One of the key concerns for the Fitzroy Park Residents Association and the Highfields Grove Management Company relates to a corridor of 10 high amenity trees that border the Hexagon cul-de-sac and the unacceptable construction impacts on them that would be caused by this proposal. Of these 10 trees, all owned by HGMC and located on their private land, two are Category A and four are Category B.

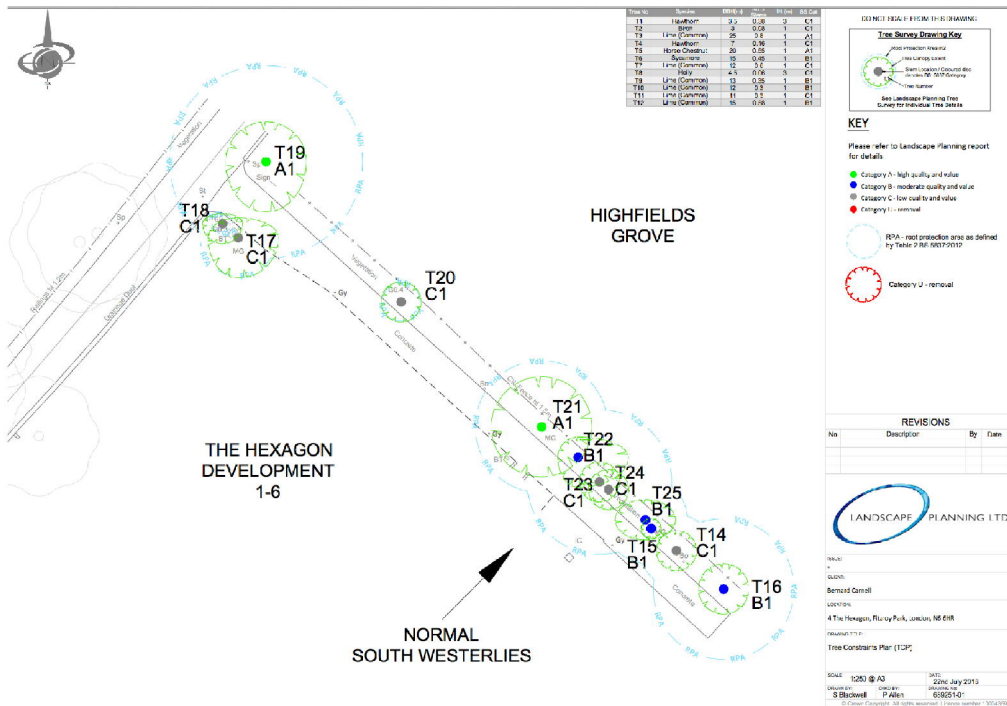
The stark reality is that this concrete cul-de-sac is 2.8m at its narrowest with these trees and other vegetation located directly along the verge. Despite reviewing the CMP in light of these dimensions, Motion Transport have proposed reversing smaller HGVs (if available) that are still 2.9m wide down the entire length of the access route. You should note that wing mirrors cannot be folded in as they are needed to complete these manoeuvres. The consequence? There is no safety buffer or allowance and these trees are highly likely to be damaged above ground and certainly below ground by these vehicle manoeuvres.

As you can see from the screen shot of Landscape Planning Ltd drawing number 689251-01 below, a survey commissioned and paid for by FPRA & the Residents, not the Applicant, the RPAs of all these trees encroach under the concrete cul-de-sac. Alan Baxter Associates who provided engineering advice for FPRA, have estimated that the total weight loading of the HGV traffic will be in the region of 5,000 tonnes including new concrete deliveries. These will pound the Hexagon cul-de-sac which has a CBR ratio of only 4%, a test also commissioned and paid for by FPRA, not the Applicant.

What Crown, the Applicant's arboricultural consultant has said is that this HGV traffic will not affect the trees because i) tree roots do not grow under roads because its too dark, and ii) in any event the use of ground guards will mitigate any degradation of the concrete surface. Yet Crown do not provide any scientific evidence to support their arguments nor have they or Motion undertaken an engineering study of the made ground beneath the concrete to determine its weight bearing capacity. Such an engineering review is a requirement of ground guard manufacture, clearly detailed in their terms and conditions, because ground guards specifically omit mitigation of compaction at depth from their benefits. The only way to mitigate compaction of depth is to re-engineer the road to an appropriate CBR level and then top with ground guards to protect the surface.

It is the compaction of the sub-soil under the concrete surface where well-regarded research has proven tree roots are found in abundance that is the nub of the issue here. The intensification of use by construction traffic along this tiny cul-de-sac and compaction of the soil and tree roots at depth poses a significant and real risk to the long-term

sustainability of these trees. Even if ground guards were deemed appropriate for surface protection, the cul de sac would need to be re-engineered to cope with the proposed increased weight loading, so the tree roots will either be damaged by this process or by uncontrolled compaction. Either way the long-term sustainability of the trees will be harmed which is clear grounds for refusal of this planning proposal.
